ROSE TREE MEDIA SCHOOL DISTRICT
SKYLIGHT / WINDOW REPLACEMENTS 2025

SECTION 00 91 13 - ADDENDUM NUMBER 2 – **DATE OCTOBER 11, 2024**

RE: Rose Tree Media School District Capital Improvement Projects 2024

1
A2.2A
RTES - MAIN LEVEL DEMO AND REFURBISHMENT PLAN
SCALE: 3/32" = 1'-0"

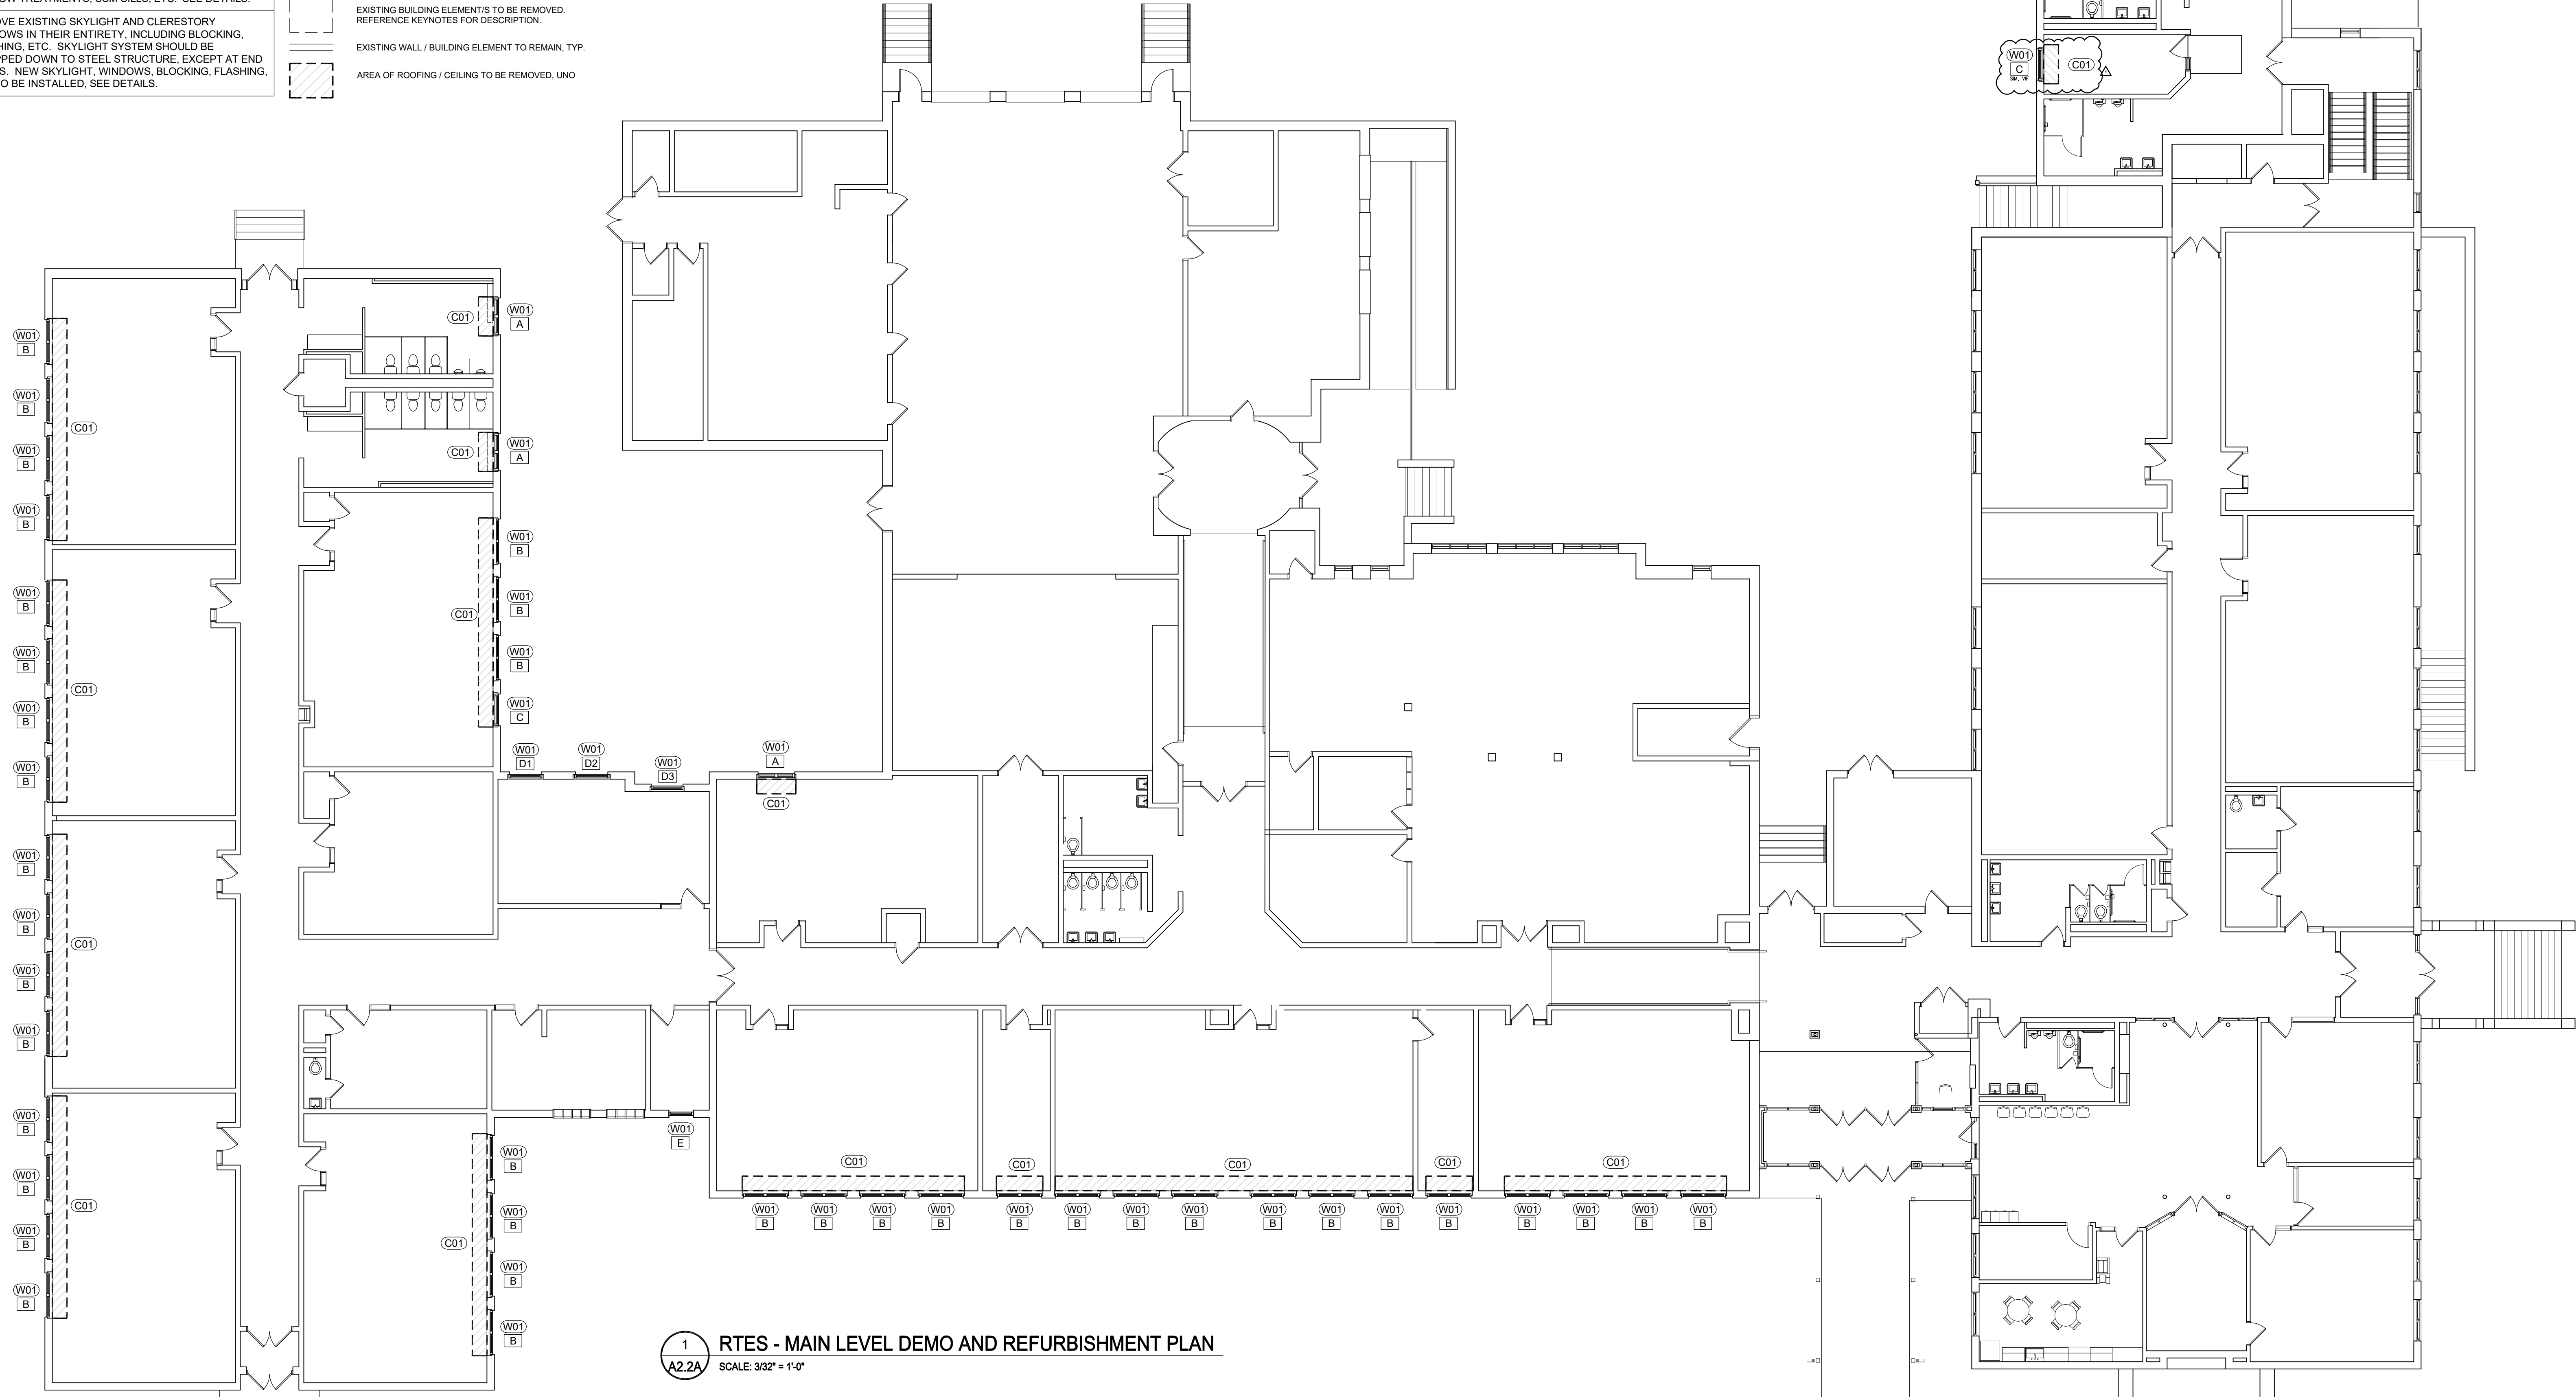
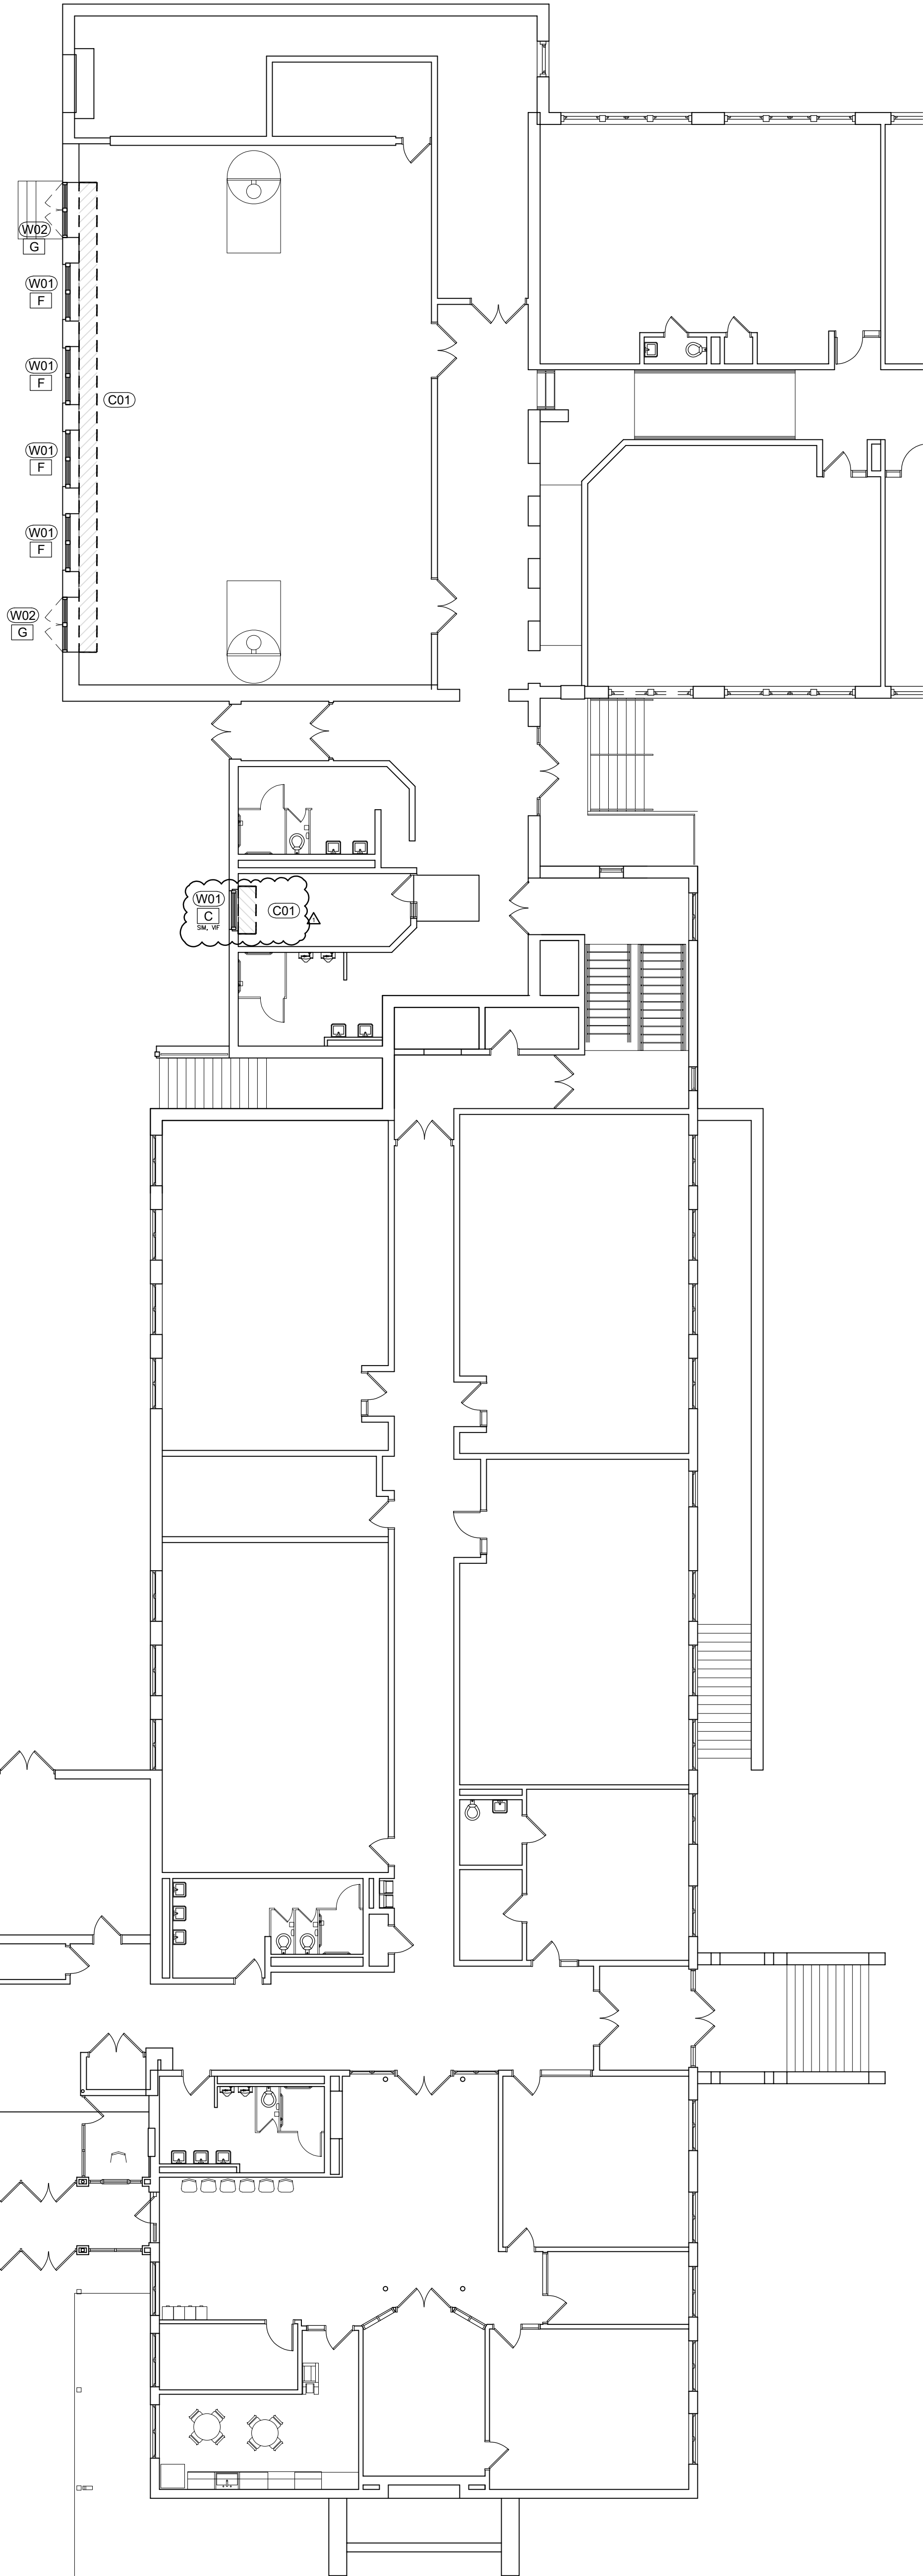
- 1.6 DEMO AND NEW WORK – KEYNOTES
 - Keynote W01 modified to read: “Remove existing window, frame, window treatments, and sill and jamb wood blocking / trim – existing head blocking to remain. Install new window, window treatments, solid surface (SSM) sills, accessories, etc. See Details.” (affects sheets A2.1A and A2.2A)
- 1.7 SHEET A2.1A, DETAIL 1 “ME – DEMO AND REFURISHMENT ROOF PLAN”
 - Additional demolition added to scope, see attached revised drawing.
- 1.8 SHEET A2.2A, DETAIL 1 “RTES – MAIN LEVEL DEMO AND REFURBISHMENT PLAN”
 - Additional window added to scope of project, see attached revised drawing.

X##	DEMO AND NEW WORK - KEYNOTES
	CEILING:
C01	REMOVE EXISTING CEILING TILE AS REQ'D FOR WINDOW REPLACEMENT AND SHADE INSTALLATION. REINSTALL TILE WHEN COMPLETED.
	WALLS / OPENINGS:
W01	REMOVE EXISTING WINDOW, FRAME, WINDOW TREATMENTS, AND SILL AND JAMB WOOD BLOCKING / TRIM - EXISTING HEAD BLOCKING TO REMAIN. INSTALL NEW WINDOW, WINDOW TREATMENTS, SOLID SURFACE (SSM) SILLS, ACCESSORIES, ETC. SEE DETAILS.
W02	REMOVE EXISTING UPPER WINDOW AND FRAME. REMOVE EXISTING WINDOW TREATMENTS UNO. INSTALL NEW WINDOW ON EXISTING DOOR HEAD. INSTALL WINDOW TREATMENTS, SSM SILLS, ETC. SEE DETAILS.
W03	REMOVE EXISTING SKYLIGHT AND CLERESTORY WINDOWS IN THEIR ENTIRETY, INCLUDING BLOCKING, FLASHING, ETC. SKYLIGHT SYSTEM SHOULD BE STRIPPED DOWN TO STEEL STRUCTURE, EXCEPT AT END WALLS. NEW SKYLIGHT, WINDOWS, BLOCKING, FLASHING, ETC TO BE INSTALLED, SEE DETAILS.
